TOPIC: 494 S Broadway Site Plan Review

494 S. Broadway - Cloud Retail - Site Plan Review #3 - March 28, 2023

Subject: 494 S. Broadway Street (M-24): Cloud Retail - Site Plan Review #3

SOUTH ELEVATION (HEIGHTS RD.)
SCALE: 3/16" = 1'-0"

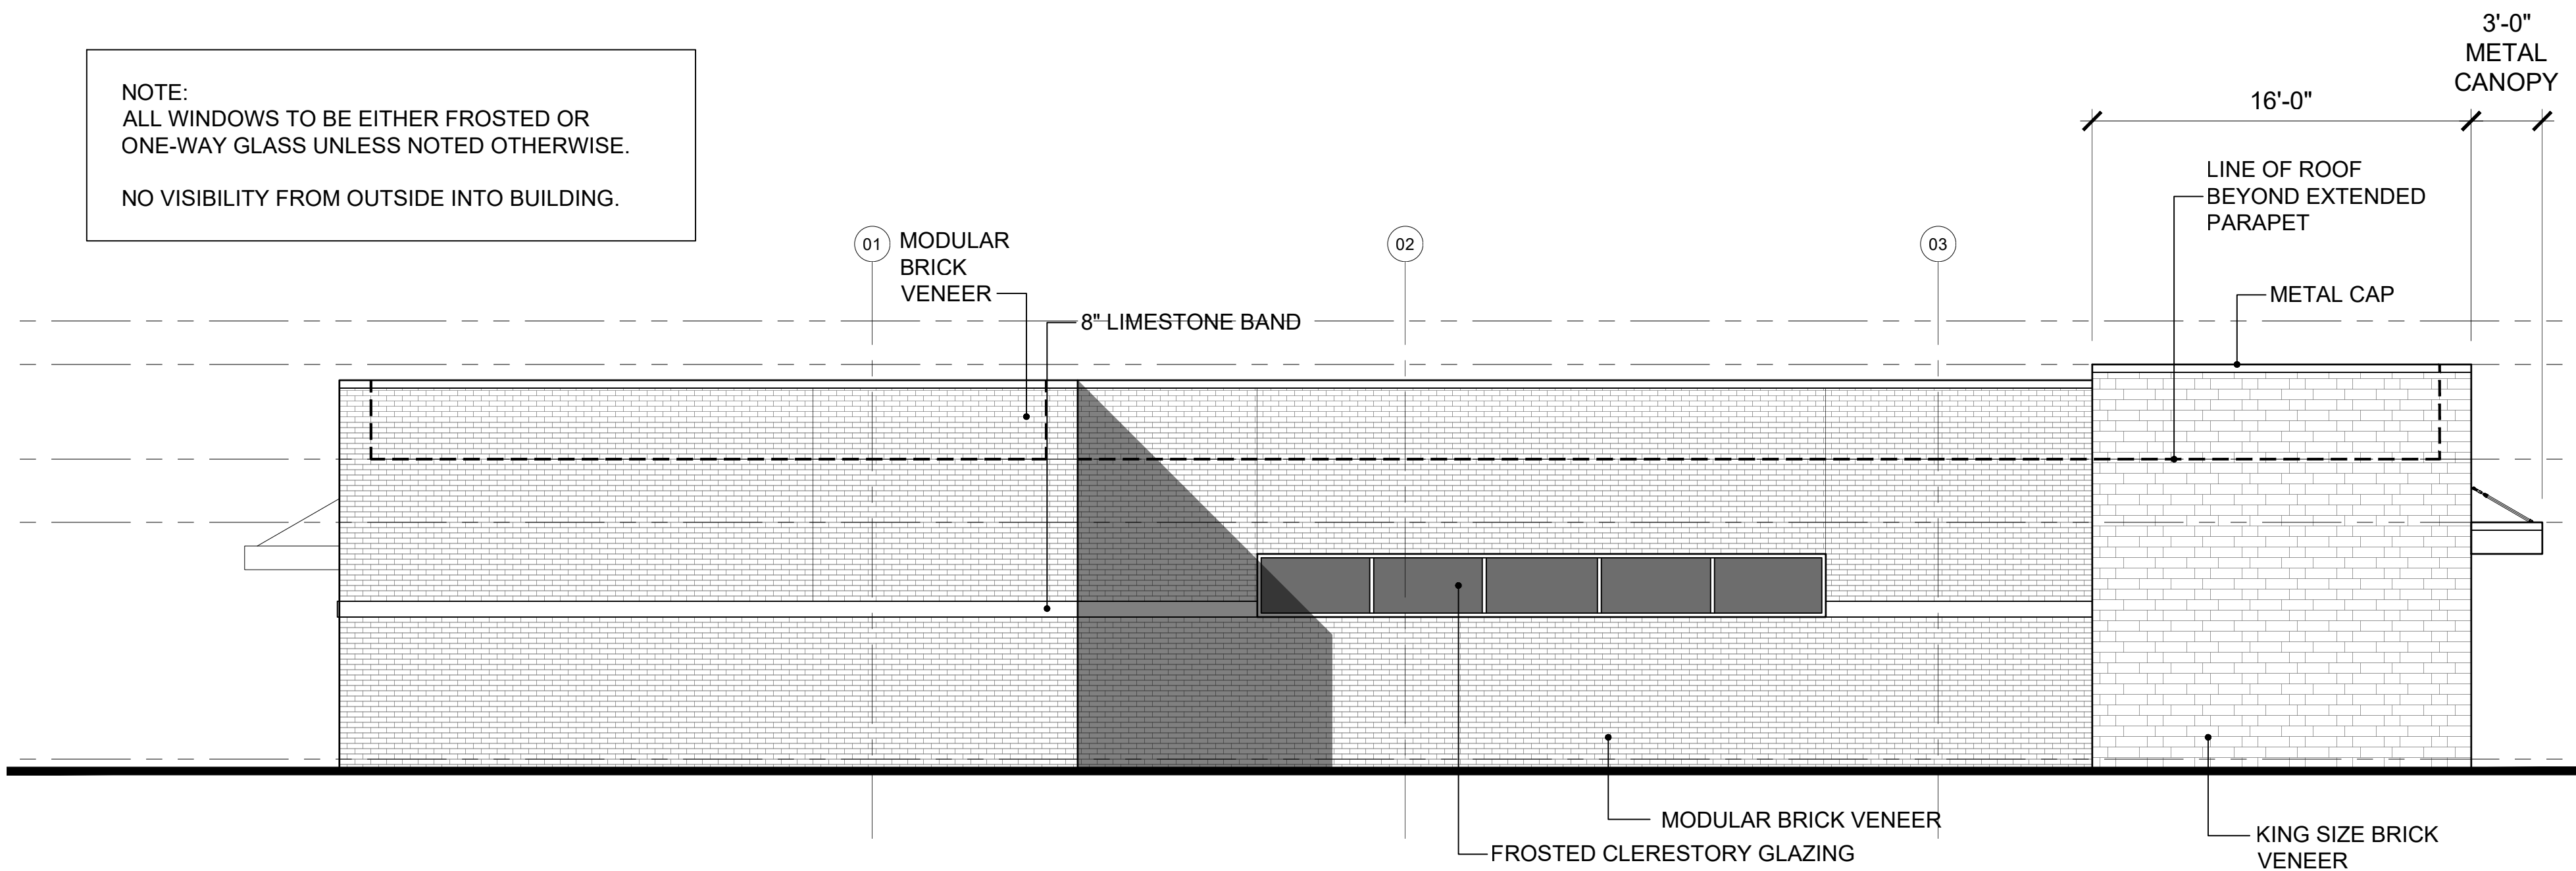
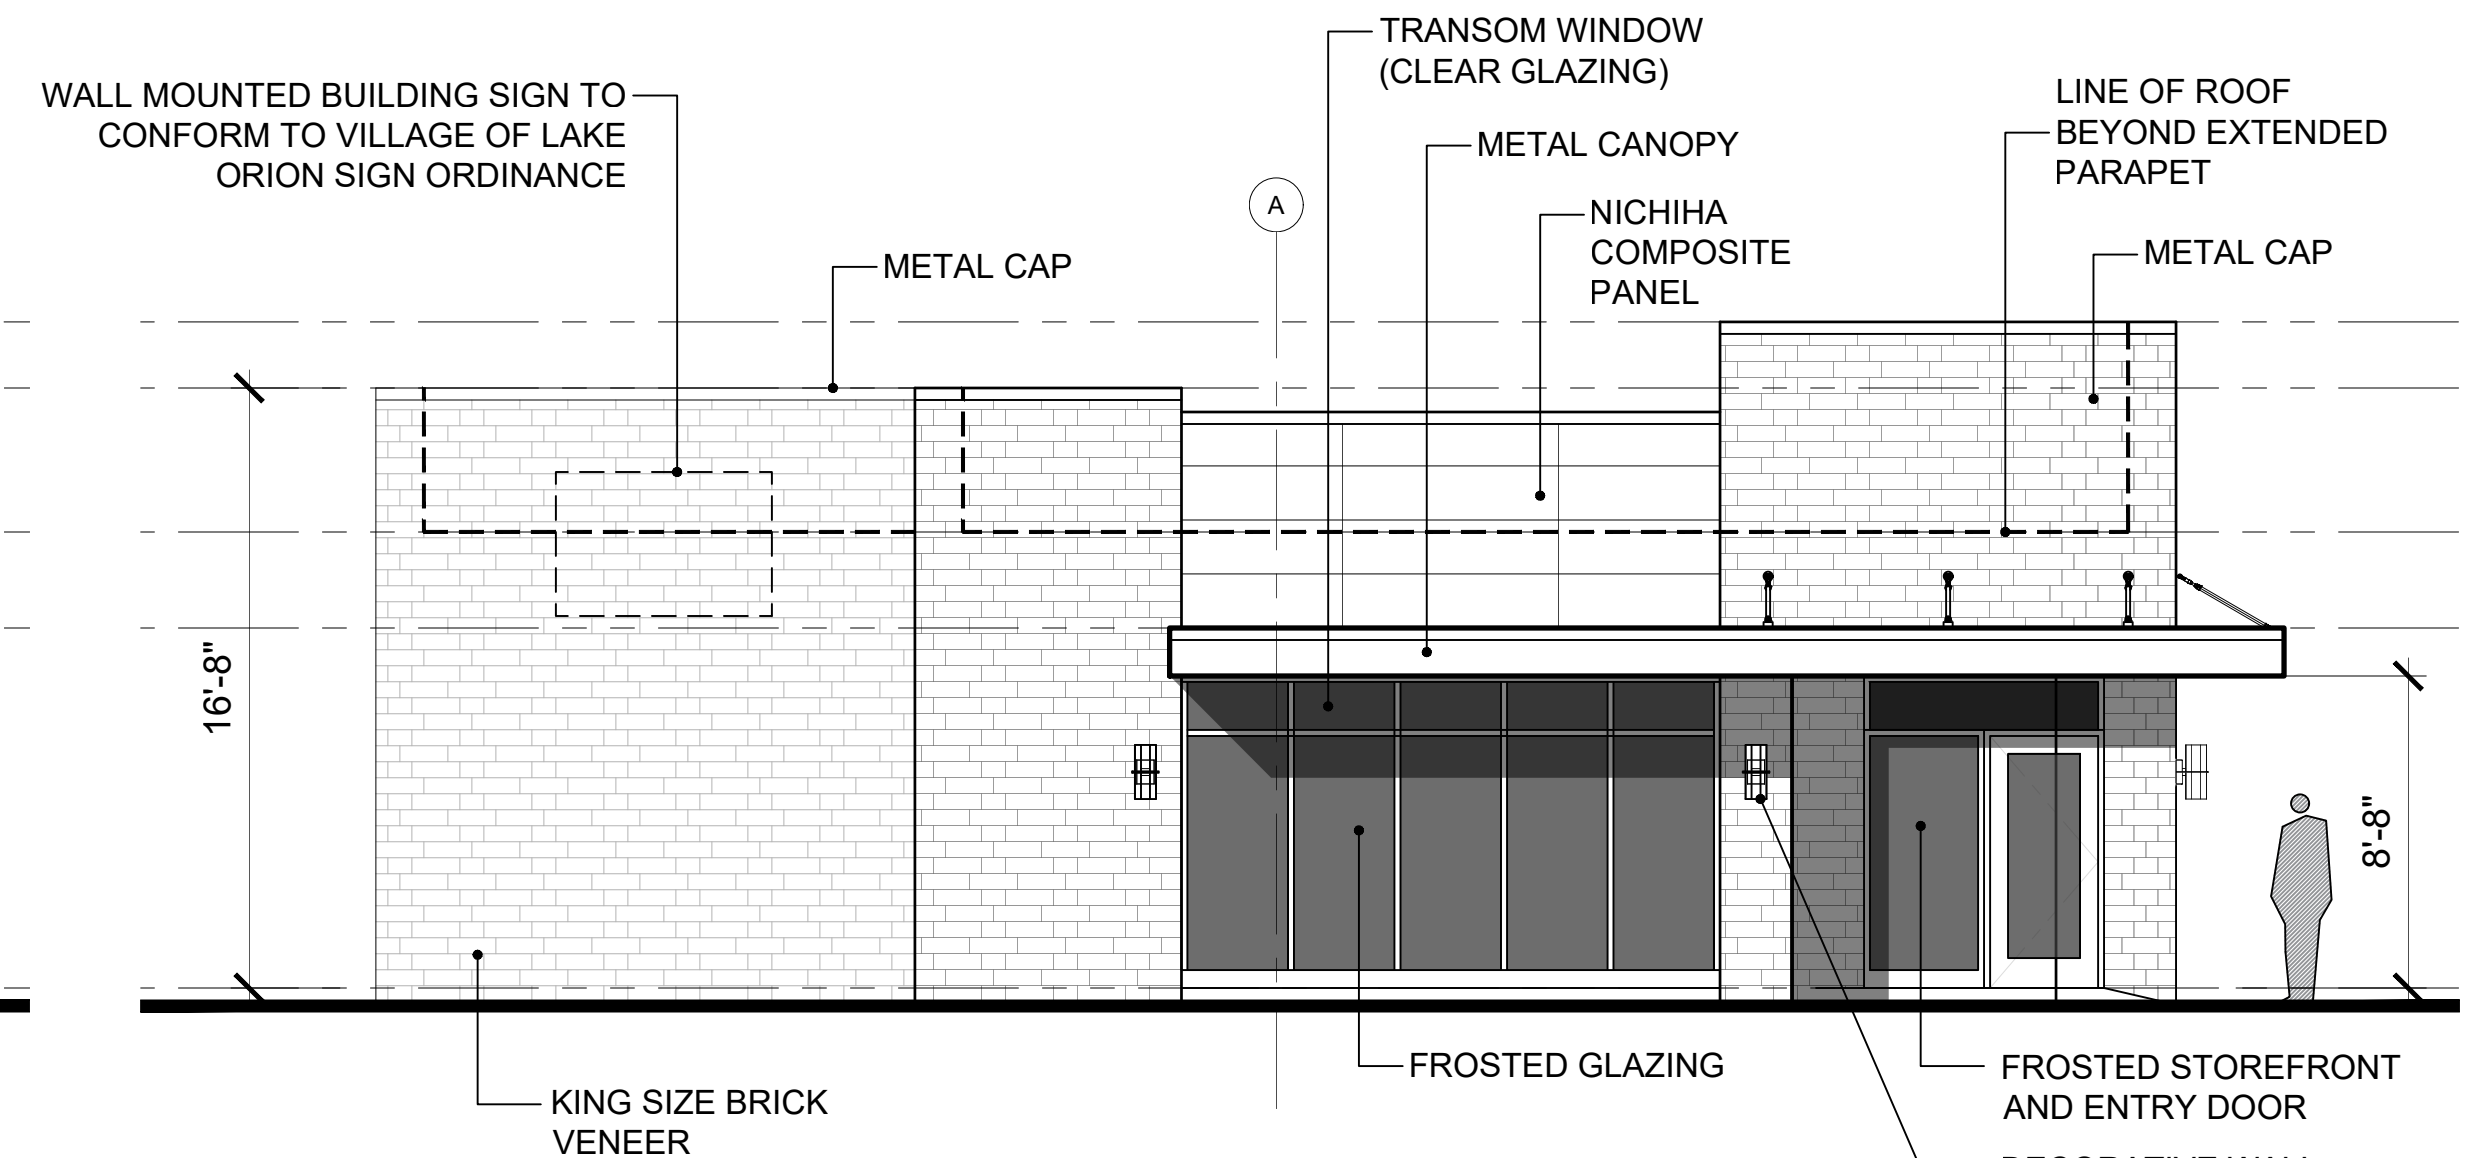
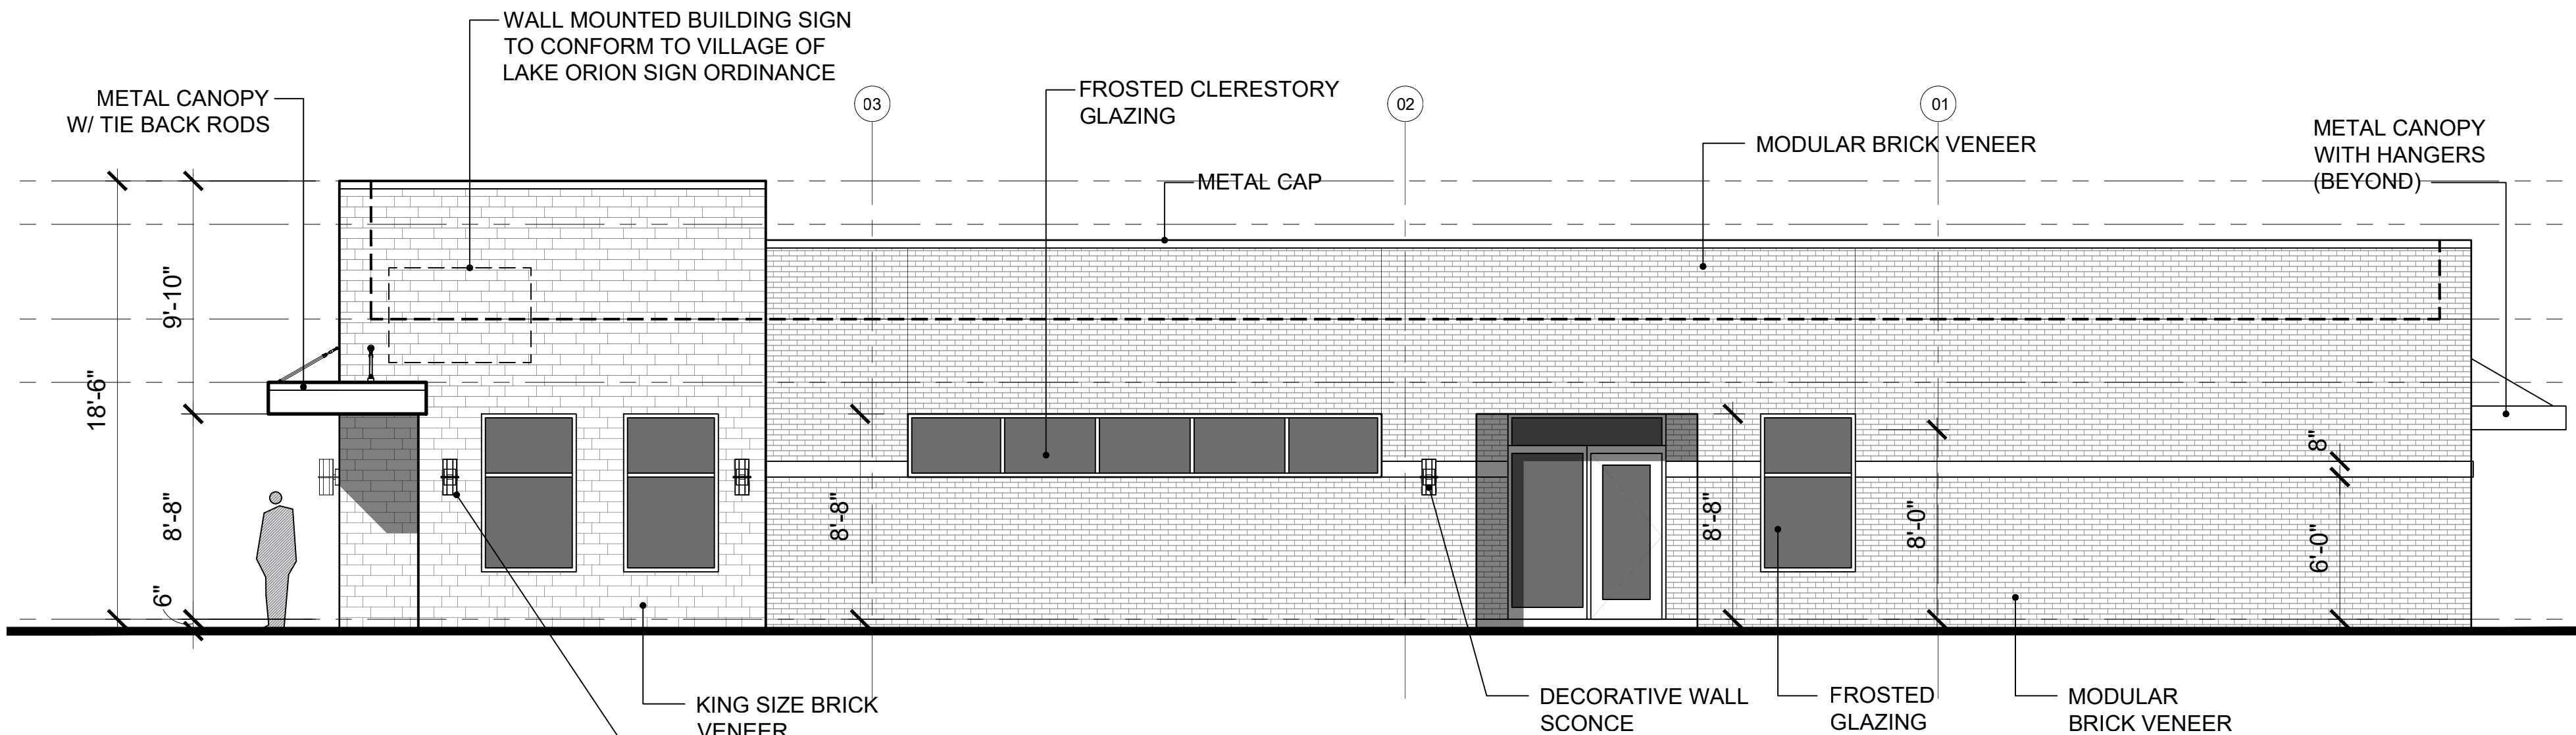
The applicant proposes a building clad largely in brick veneer with limestone banding, fiber cement panel accents, and a metal canopy. Additional glazing is proposed for the north and east elevations. Material samples have been provided to the Planning Commission, approving the applicant's selection.
- Signage.** The location of a proposed monument sign is also detailed along S. Broadway; this sign will also be reviewed and permitted under separate application; no signage is approved as part of this site plan.

decorative sconce lighting for the north and east elevations, as seen on Sheet A3.1. A cut sheet for the sconces must be provided and these fixtures must be reflected on the photometric plan, which still shows the previous wall packs and incorrect fixture locations and mounting heights.
